Subject: Final Report - DER 83-51
A 50.55(e) Reportable Condition Relating to Unit 1 Auxiliary
Feedwater Pump Failed To Meet Requirements of Hot Functional
Tests.
File: 84-019-026; D.4.33.2

FINAL REPORT - DER 83-51
DEFICIENCY EVALUATION REPORT 50.55(e)
ARIZONA PUBLIC SERVICE COMPANY (APS)
PVNGS UNIT 1

ORIGINAL TEST CONFIGURATION

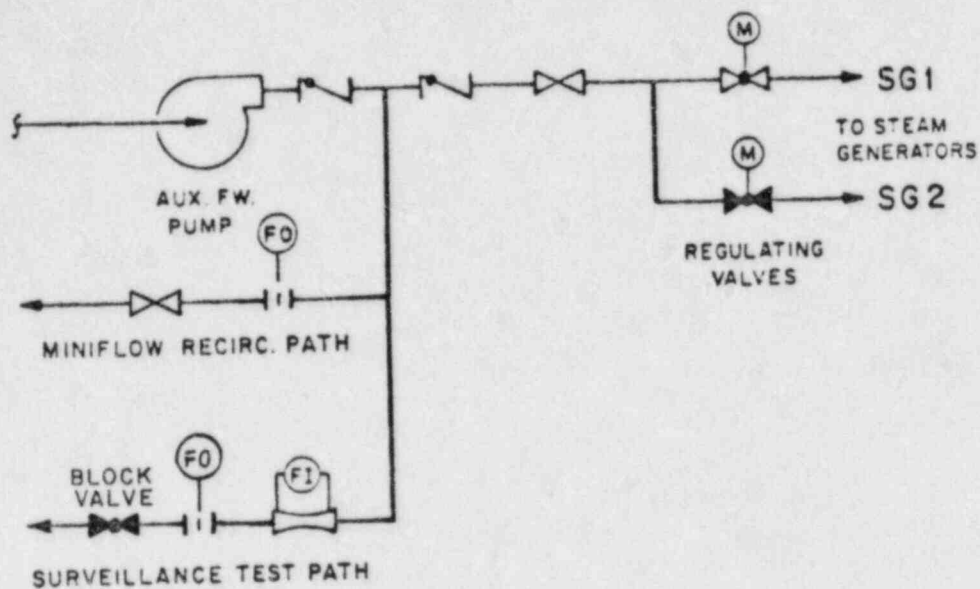
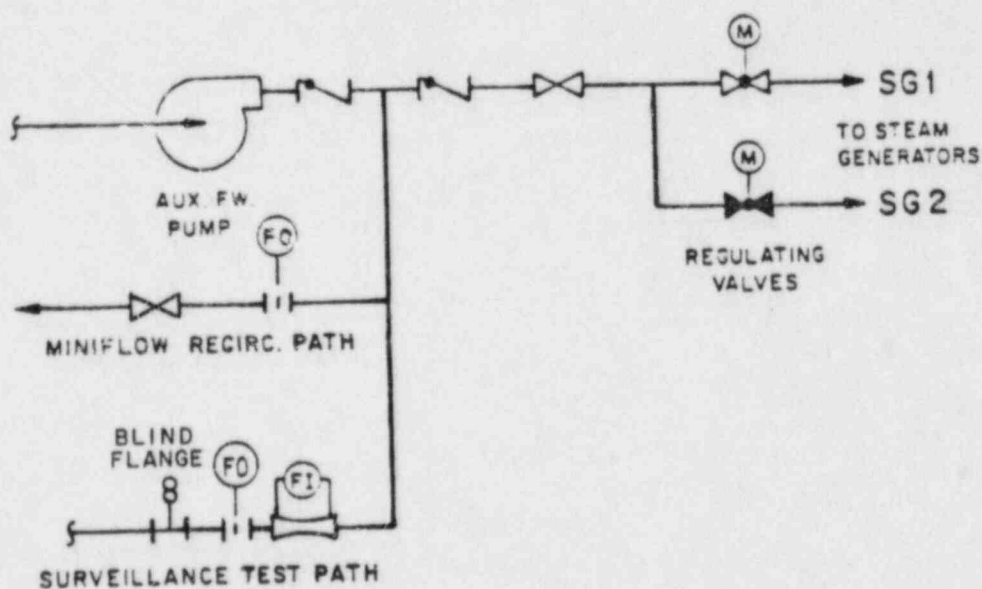
Further investigation revealed that the root cause of the deficiency was that the surveillance test path block valve 1PAFAV018 was leaking. This condition is noted on NCR SM2961. As a result of the leaking block valve, the flow to the steam generator was reduced.

The surveillance test path was provided to perform full flow, periodic testing of the pump. However, there are no requirements for a full flow surveillance test loop in the ASME Codes and the technical specifications. The overall system operability is demonstrated at 18-month intervals by directly pumping to the steam generators. Therefore a spectacle blind flange was installed in the surveillance path and the block valves were removed. The pump was tested again in the same configuration as before except for the addition of the spectacle blind flange to eliminate the leak path as shown in the attached sketch. Evaluation of the test data indicates that the pump can deliver the required flow at rated head.

Investigation of the leaking block valve indicated that the valve leakage was common to both the "A" train and "B" train block valves. Even though the valves were not designed for flow modulation, they had to be throttled to obtain the required flow rates during surveillance testing. The valves did not withstand the conditions that resulted from throttling and as a result, were damaged and leaked. The subject valves were designed for use as isolating valves. As such, the installation of these valves in the surveillance path is a case of misapplication and incorrect installation.

DCPs 1SM-AF-062, 2SM-AF-062, and 3CM-AF-062 have been issued to eliminate the surveillance path by removing the block valves and adding a spectacle blind flange. SARCEN 1165 has been issued to delete reference to the surveillance flow path from the FSAR. These DCPs will be implemented prior to fuel load in each unit.
